Addendum #3

Bid Opportunity: 25-7693-RFT - Elmira District Secondary School Weight Room Renovation Closing Date: Thursday, March 20, 2025 2:00 PM

WRDSB-Elmira District Secondary School Weight Room Renovation
WRDSB Project No.: 25-7693-RFT
WF Project No.:2022-0277-15

March 13, 2025
ADDENDUM #3
Page 1 of 2

SCALE	1:200	SHEET NO.:
DATE	2025-02-10	C100
PROJECT NO.:	2022-0277-15	
DRAWN BY:	TG	
CHECKED BY:	JZ

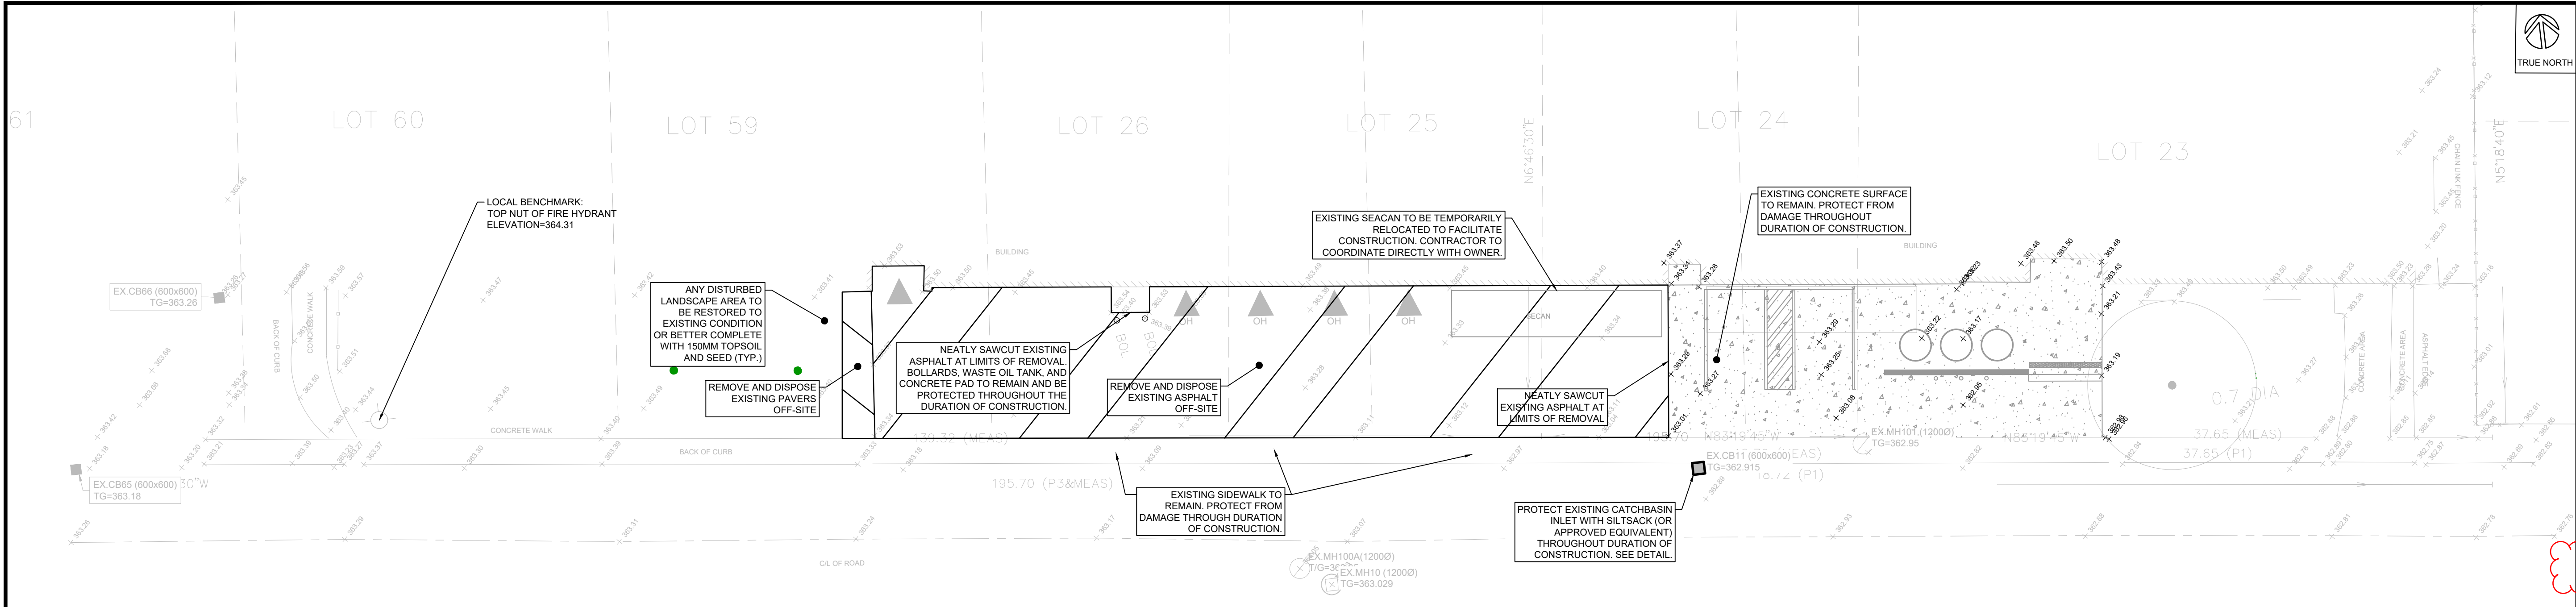
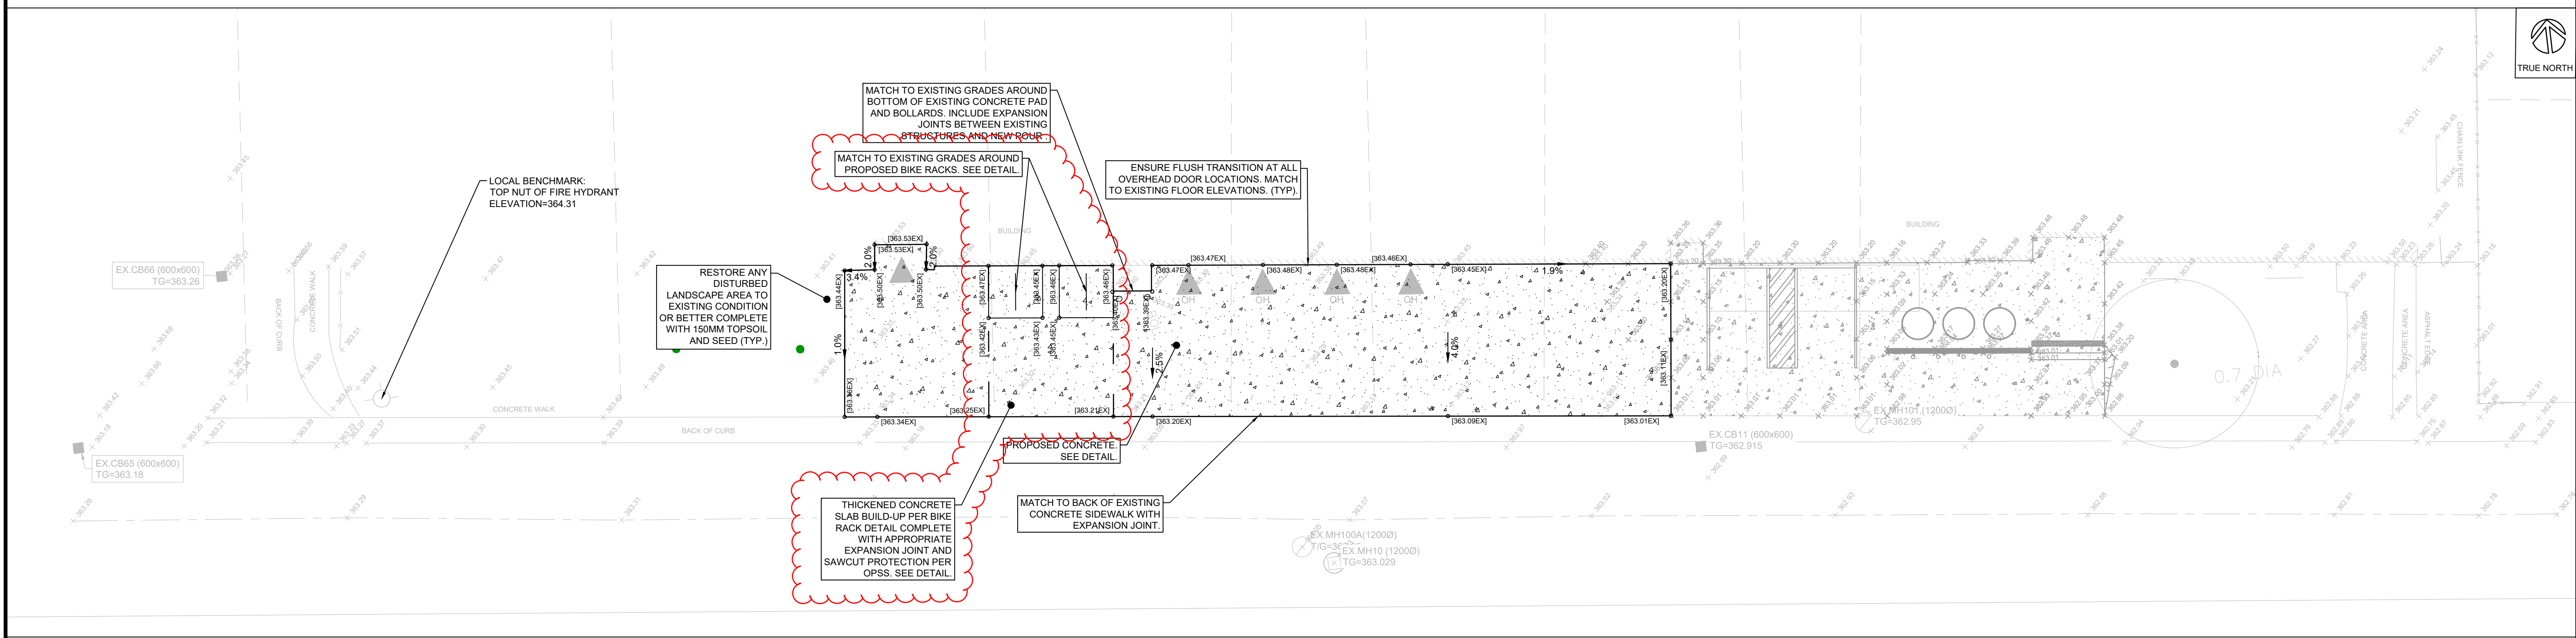
C100

1. Add bike rack and associated thickened concrete slab per schoolboard request.

SCALE: 1:500	SHEET NO.:
DATE: 2025-02-10	C500
PROJECT NO.: 2022-0277-10	
DRAWN BY: TG	
CHECKED BY: JZ

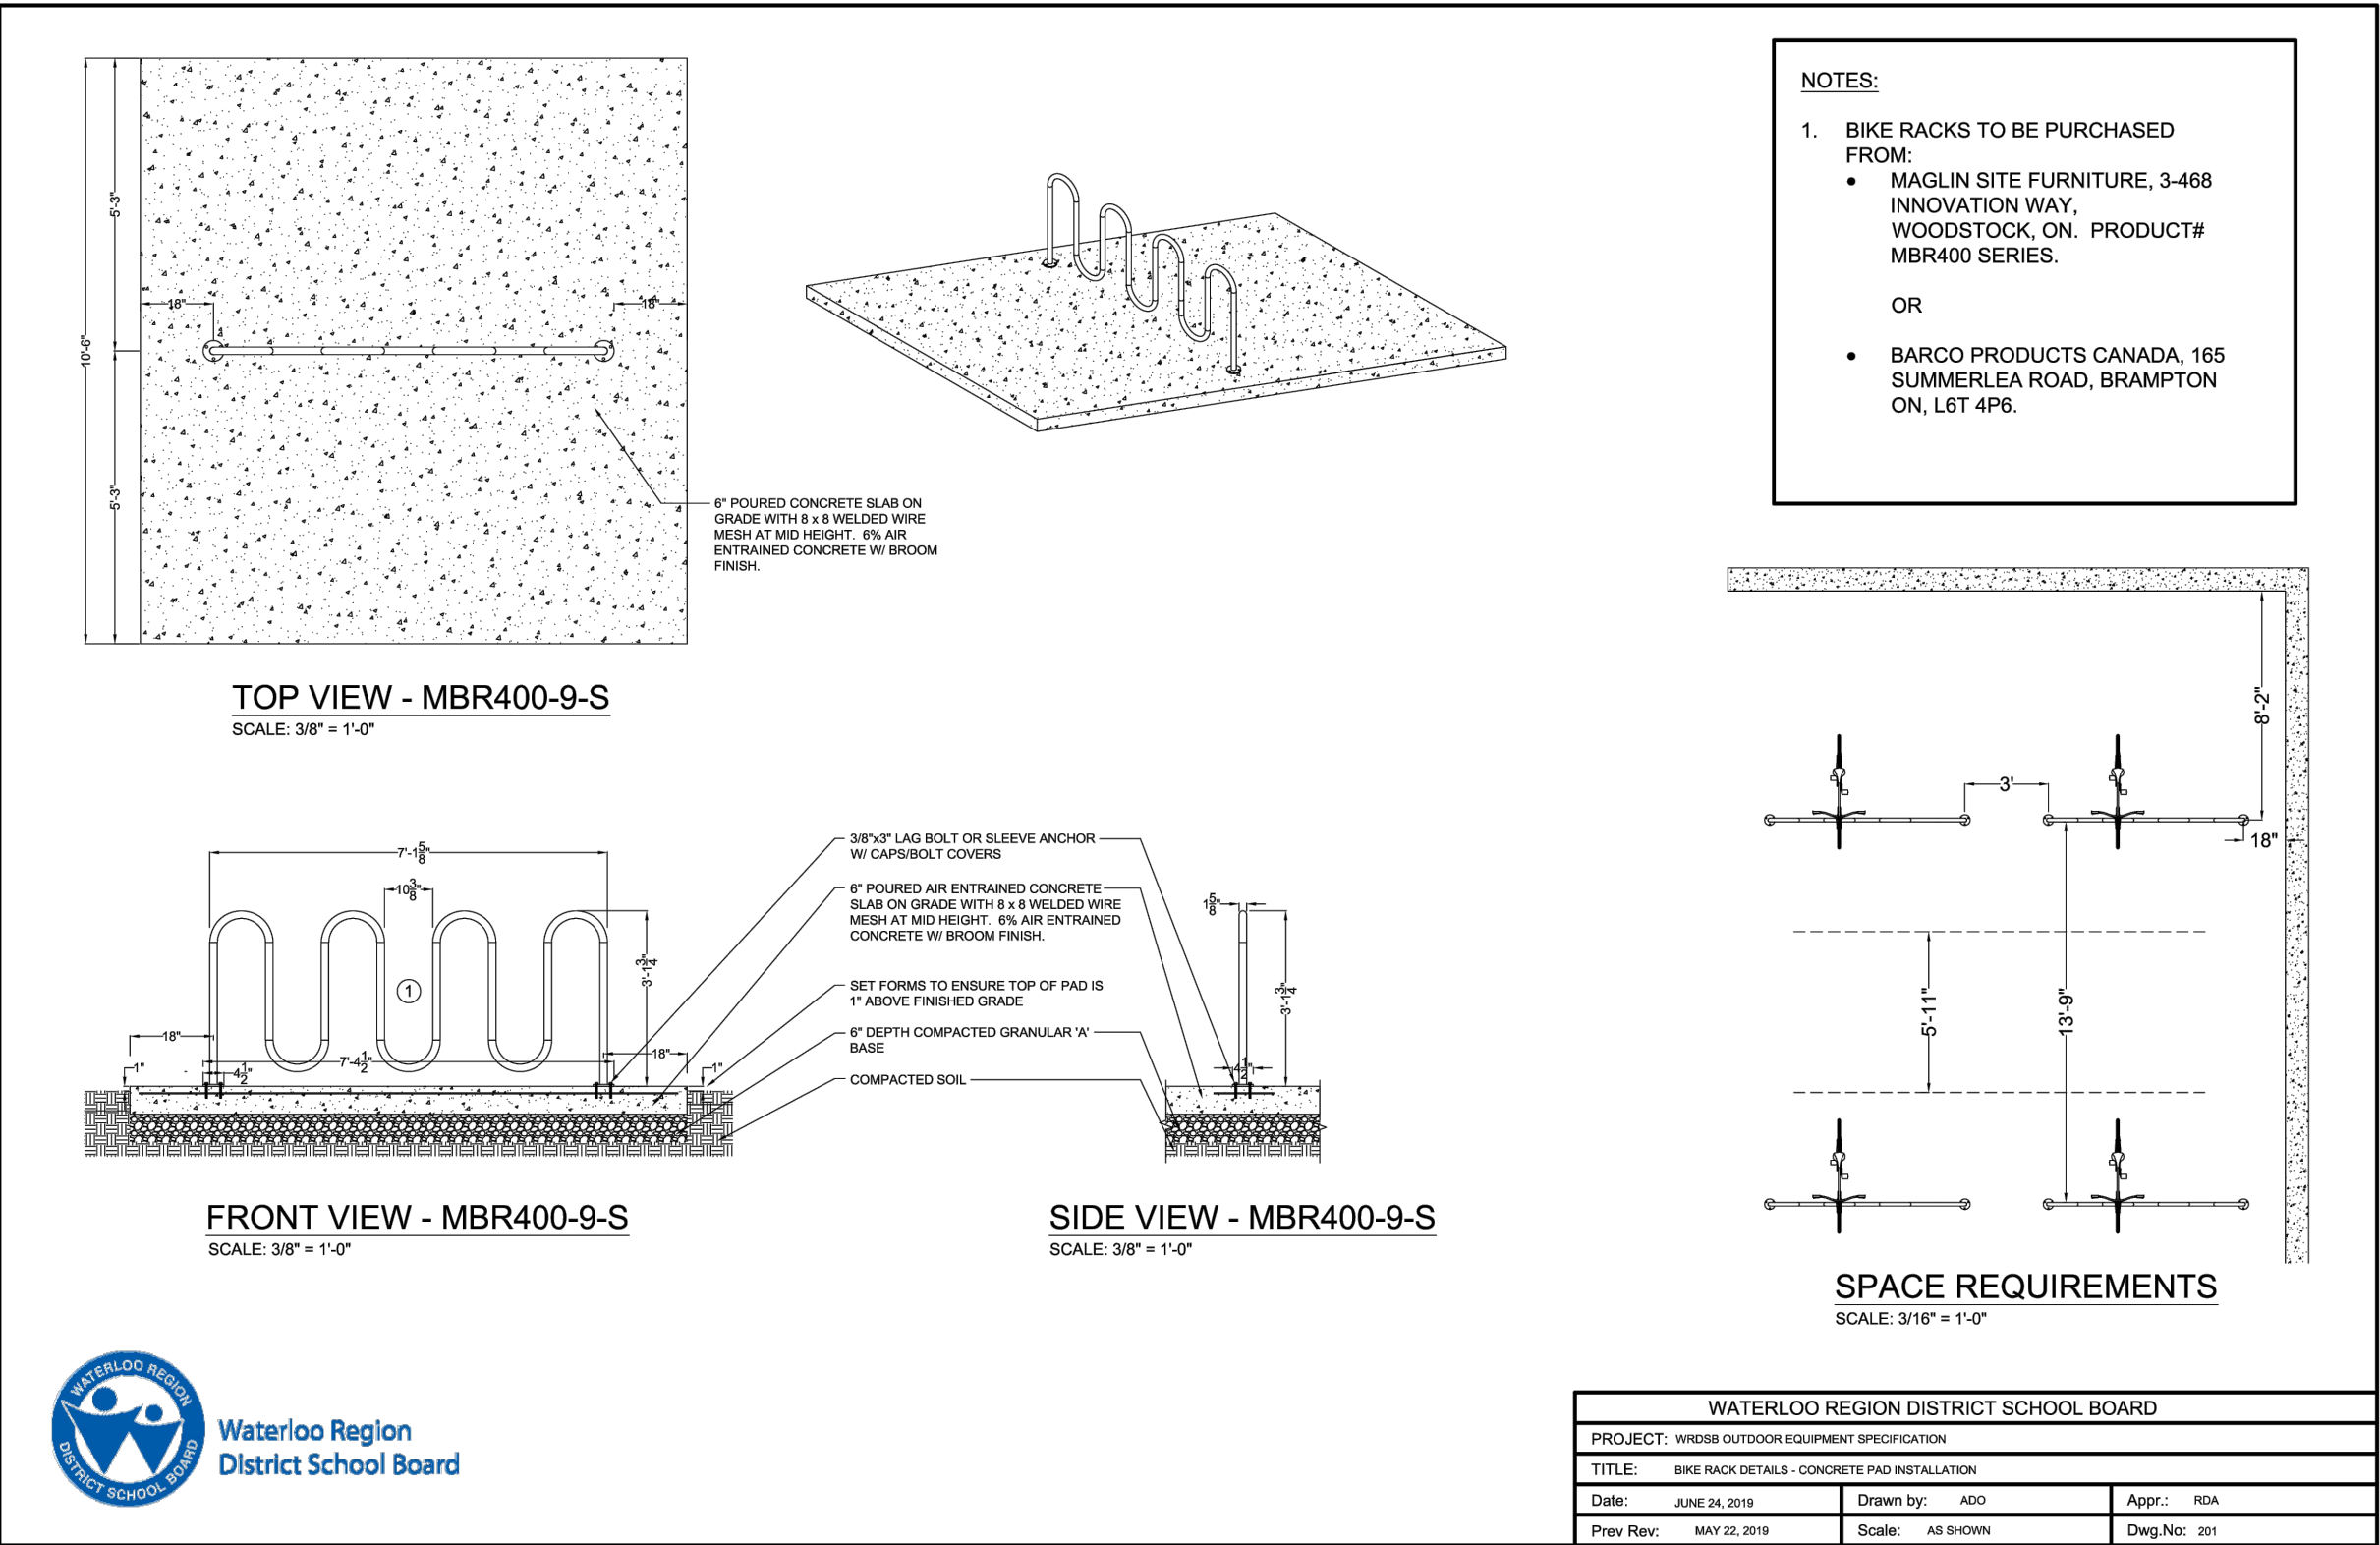
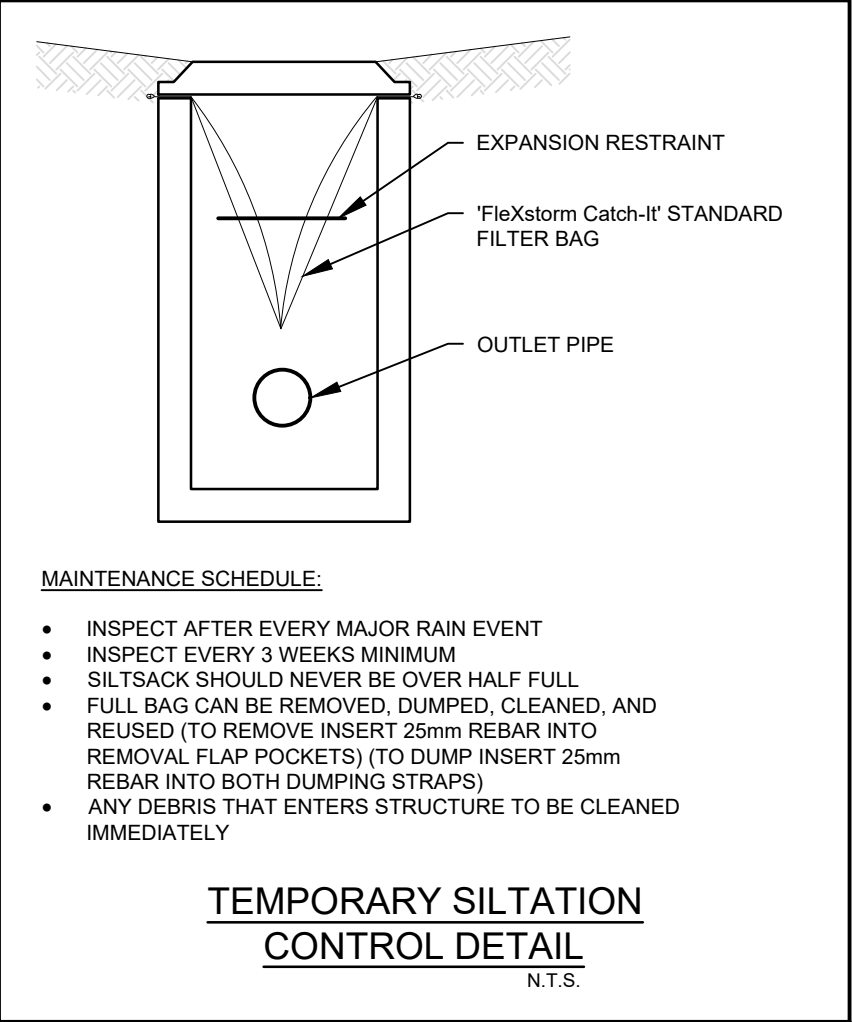
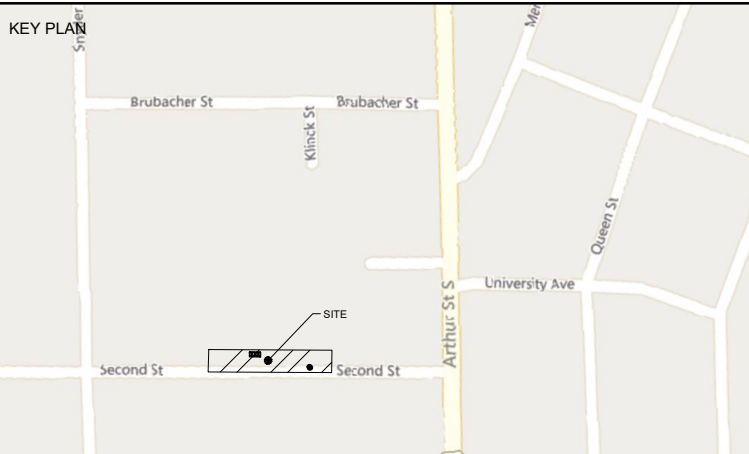
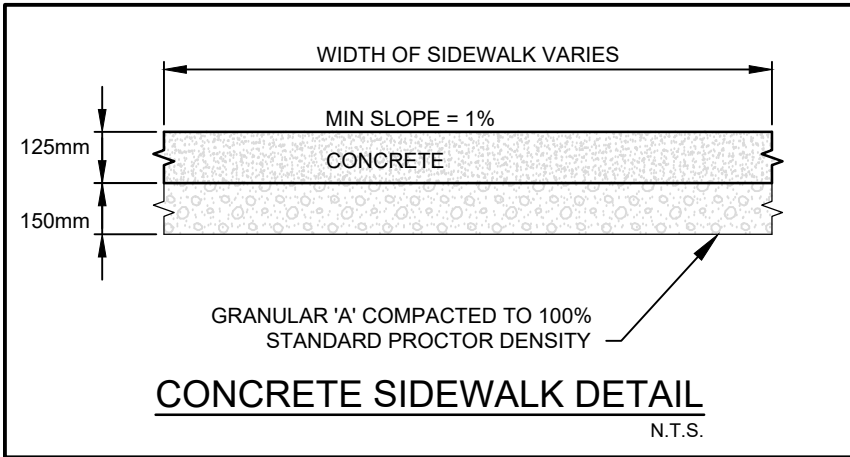
C500

1. Add schoolboard bike rack typical detail.
